Eastern Regional Power Committee

Sub: Minutes of the 157th PCC meeting held on 16.04.2026

MINUTES
OF
157th PCC MEETING

2.4 Tripping of Ramchandrapur 220 kV Bus-1 due to LBB Operation

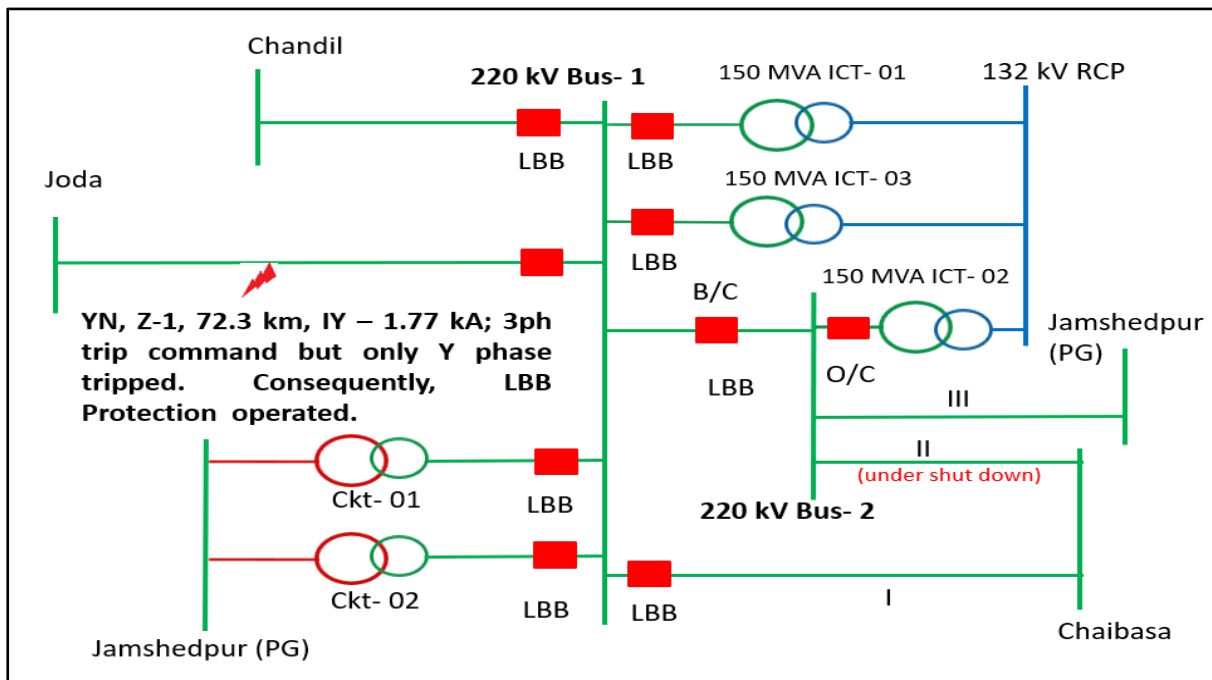
At 12:04 Hrs on 04.04.2026, Y-Earth fault occurred in 220kV Ramchandrapur-Joda line, which was cleared by Z-1 protection. However at Ramchandrapur end, only Y-pole tripped while remaining B & R poles failed to operate(stuck condition), leading to Main Bus – 1 LBB operation. During the event 220kV Chandil, 220 kV Joda, 220 kV Jamshedpur (PG) – 1 & 2, 220 kV Chaibasa – 1 & 150 MVA ICT – 1 & 3 got tripped.

- **Three phase tripping** for phase to ground fault in 220kV Joda-Ramchandrapur line.
- Reason for **non-opening** of R & B pole of 220kV Joda-Ramchandrapur at Ramchandrapur end.

JUSNL representative explained that on 04.04.2026, a Y–Earth fault occurred on the 220 kV Ramchandrapur–Joda line for which the relay at Ramchandrapur end sensed the fault in Zone-1 protection and issued trip command. However, only the Y-phase pole tripped, while the R and B poles failed to operate (stuck condition), resulting in operation of Main Bus–1 LBB protection.

He informed that breaker timing tests were carried out, and all three poles were found to be operating simultaneously with no discrepancy observed.

He further informed that due to carrier fail issue at Joda end. The carrier protection is not working, and this resulted in three phase tripping for a single phase to ground fault.

PCC advised JUSNL & OPTCL to carry out testing of carrier scheme for 220 kV Joda-Ramchandrapur line and resolve the carrier fail issue at the earliest.

PCC further advised JUSNL to submit a compliance report on the recommendations of third party protection audit for 220 kV Ramchandrapur S/s.
